## DETERMINATION OF NON-SIGNIFICANCE

**City of Bellevue  
Development Services Department  
Land Use Staff Report**

Proposal Name: **Pacific Regent II**

File Number: **10-117762 -LD**

### Tower One Upgrades

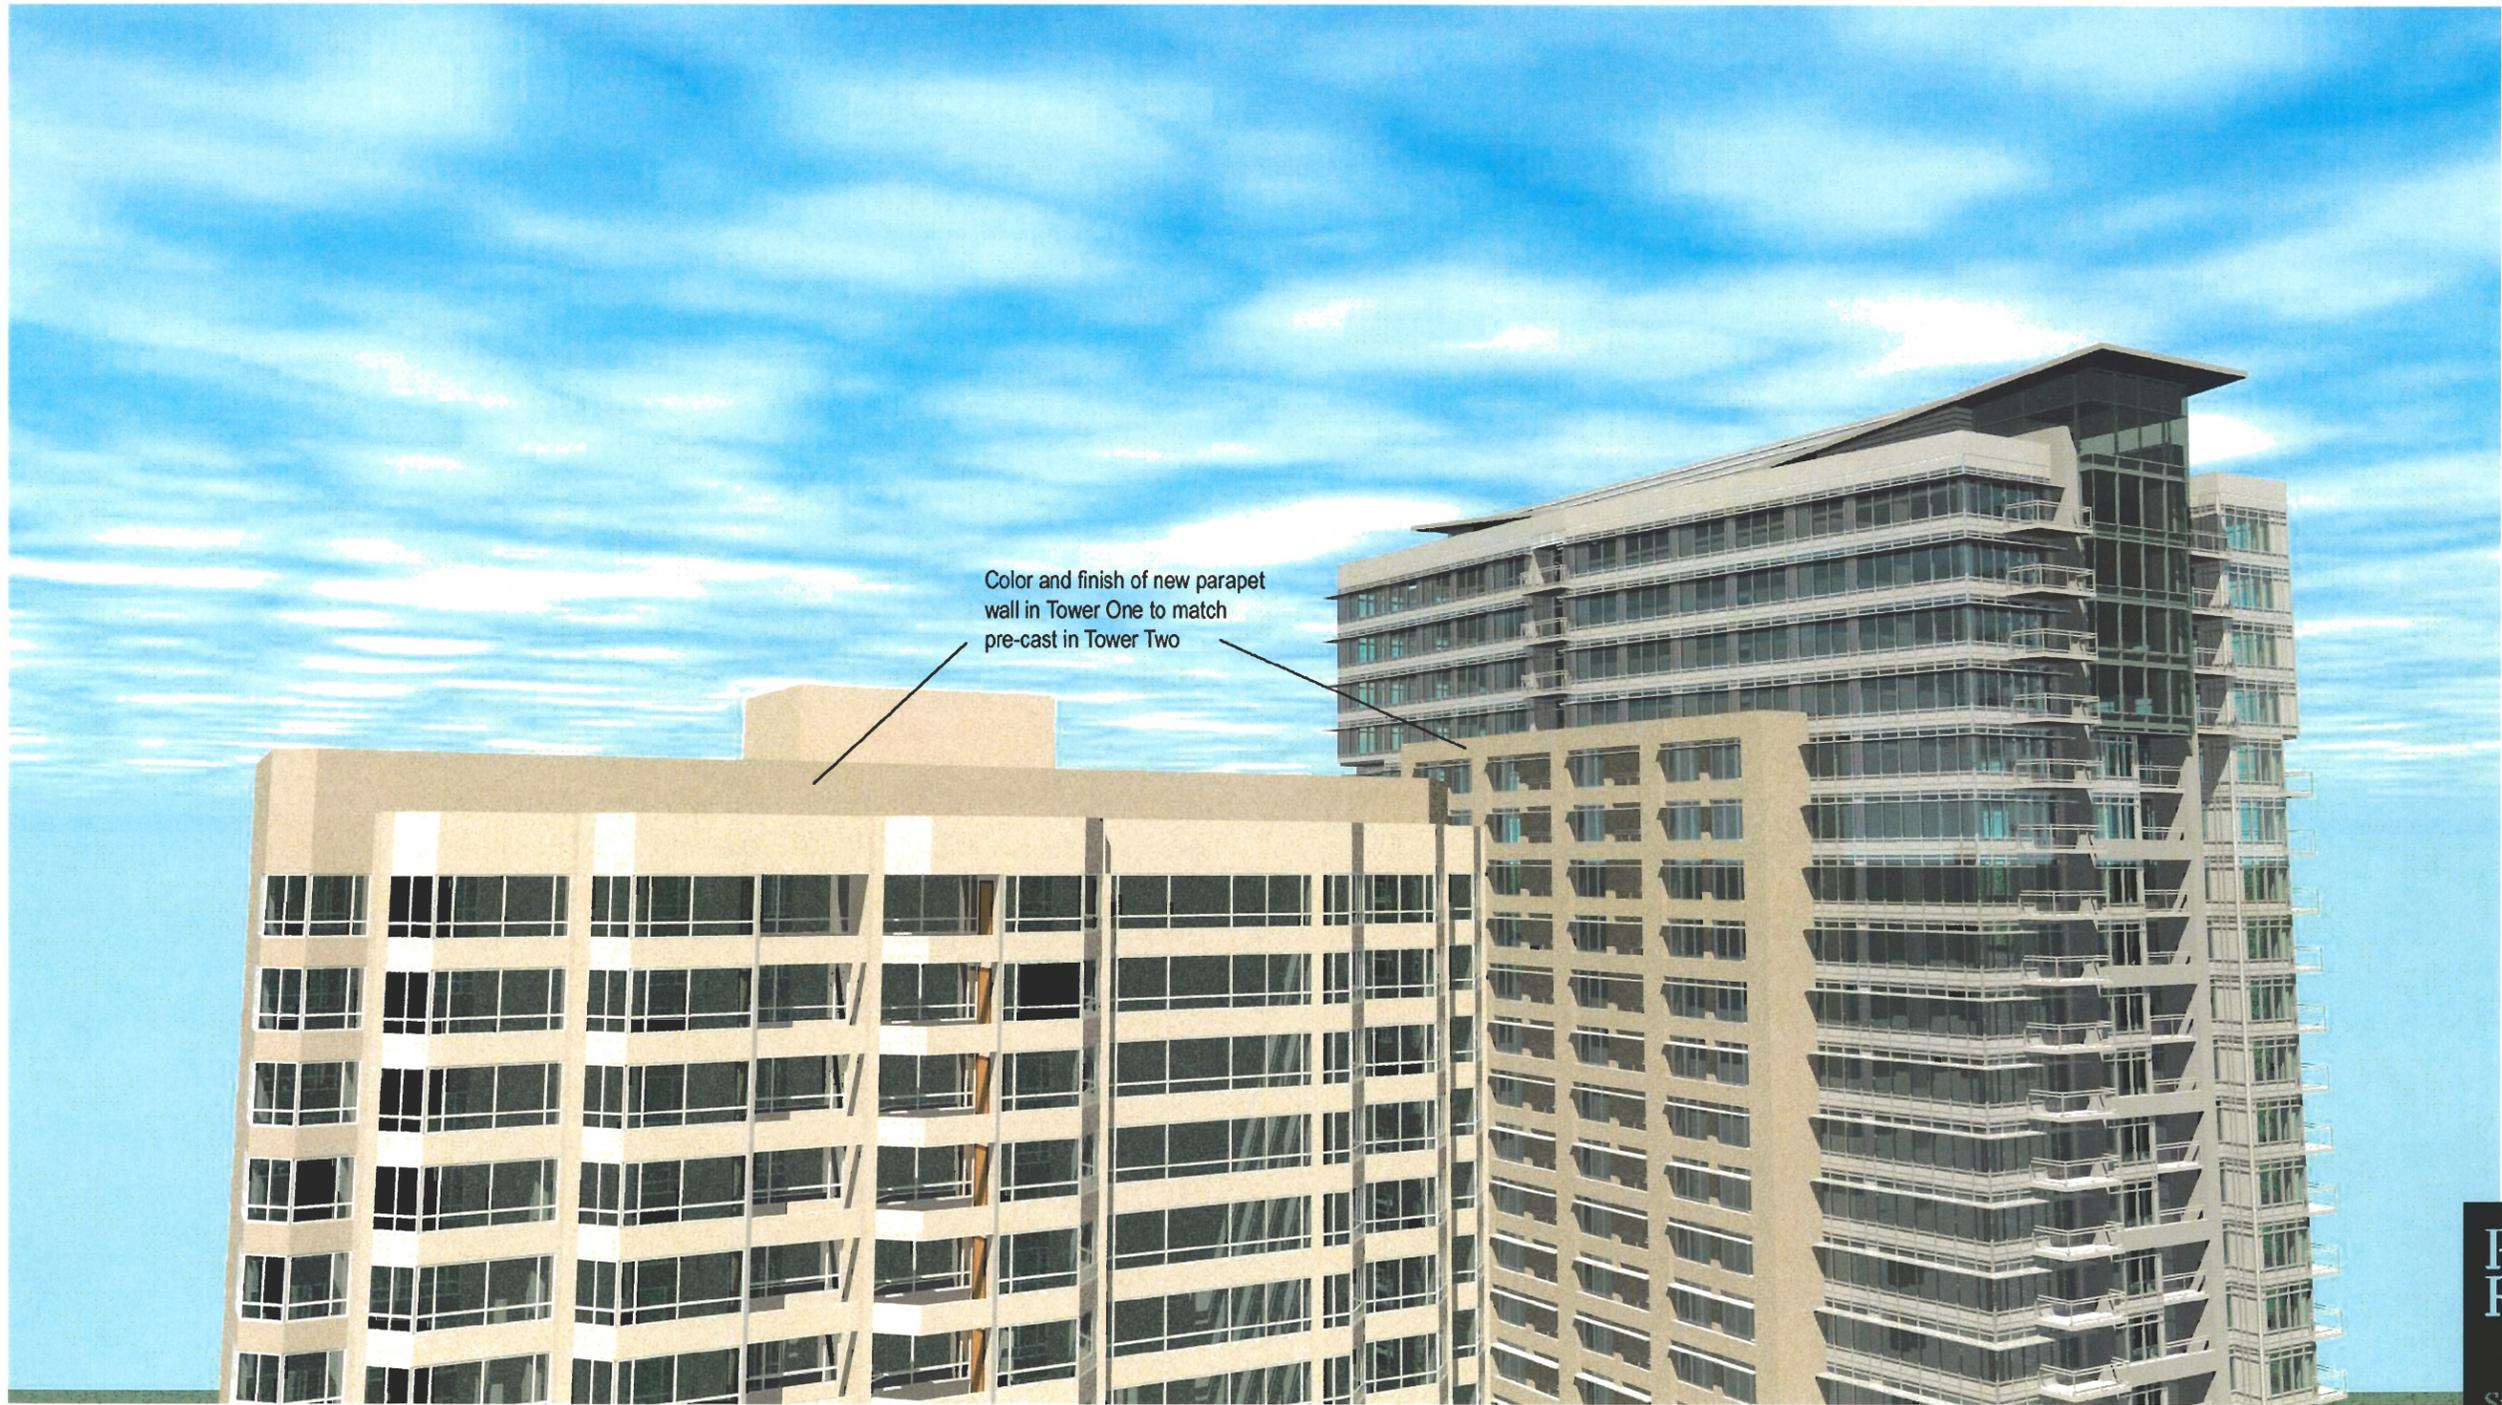
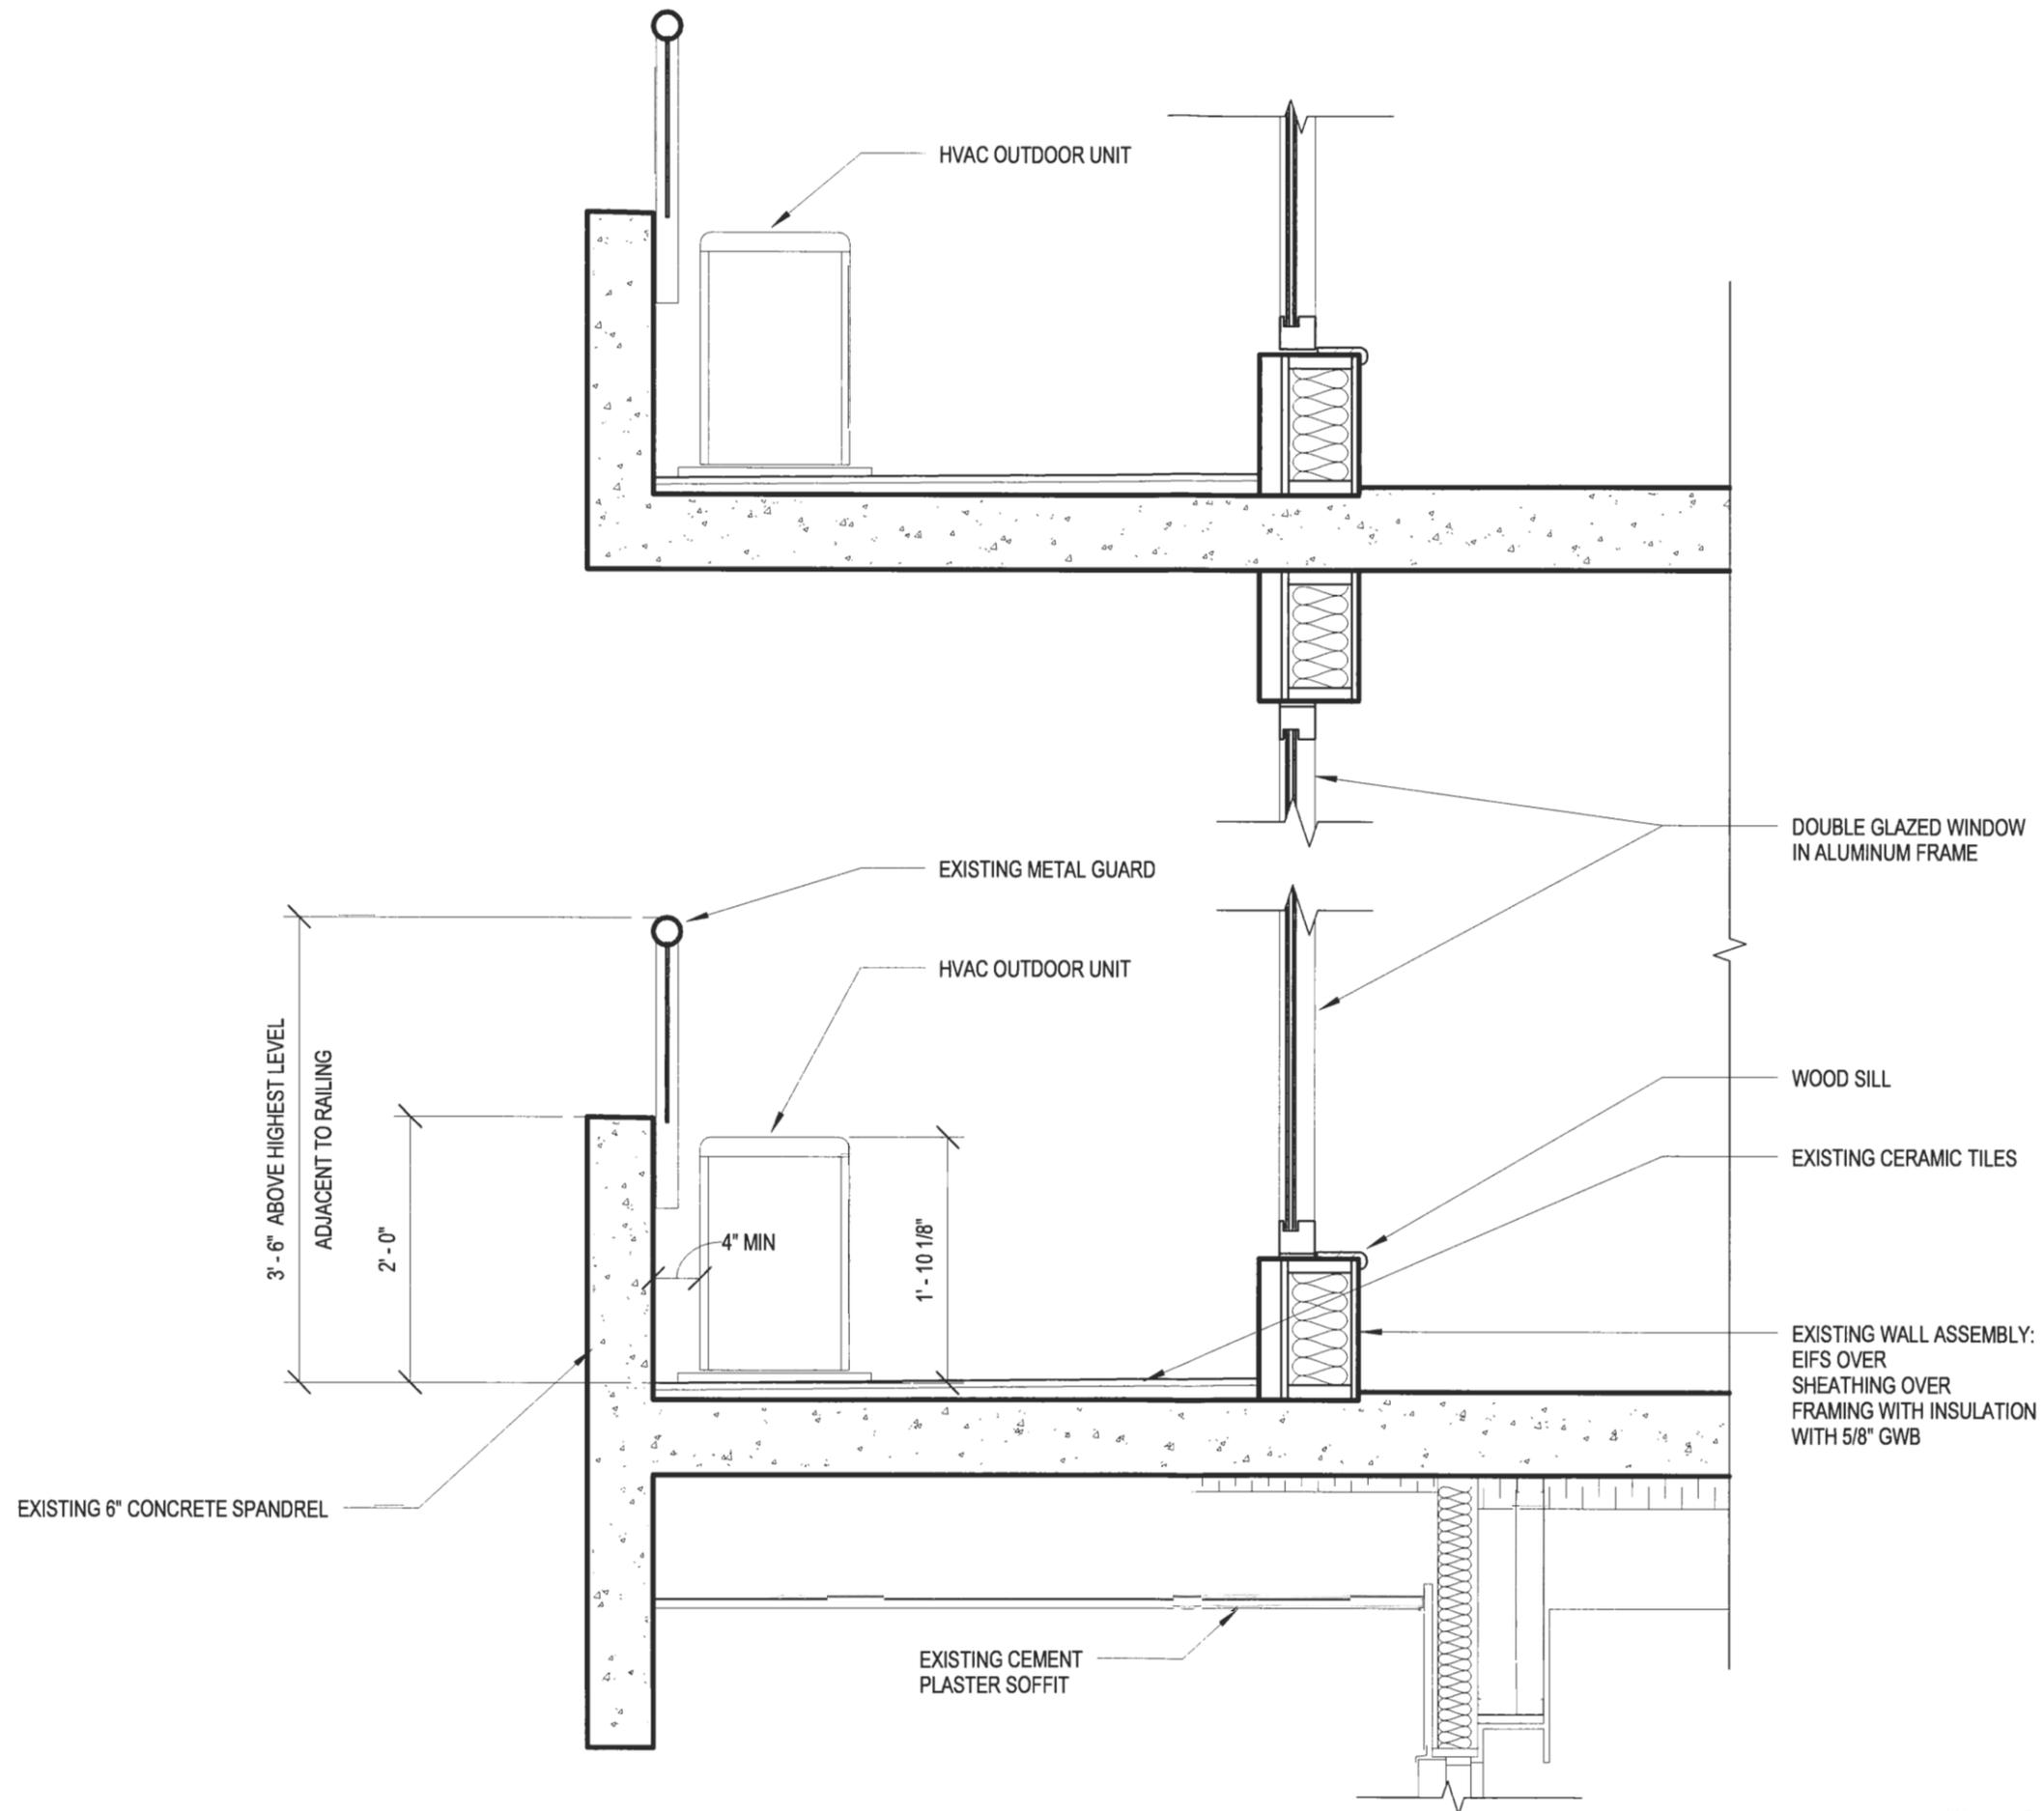
The existing tower was initially to remain unchanged; but the proposal was revised to unify the parapet and mechanical equipment screen in order to update the overall design of the building, improve its relationship to the proposed building and its Signature on the Downtown skyline. The exterior color was also revised. Together these design changes will promote compatibility with the proposed building and help achieve a visually cohesive project.

Extend roof parapet at north and south ends 6'-0" to create articulation for the roof line. The new parapet will also optically soften the harsh protrusion of the existing mechanical penthouse.
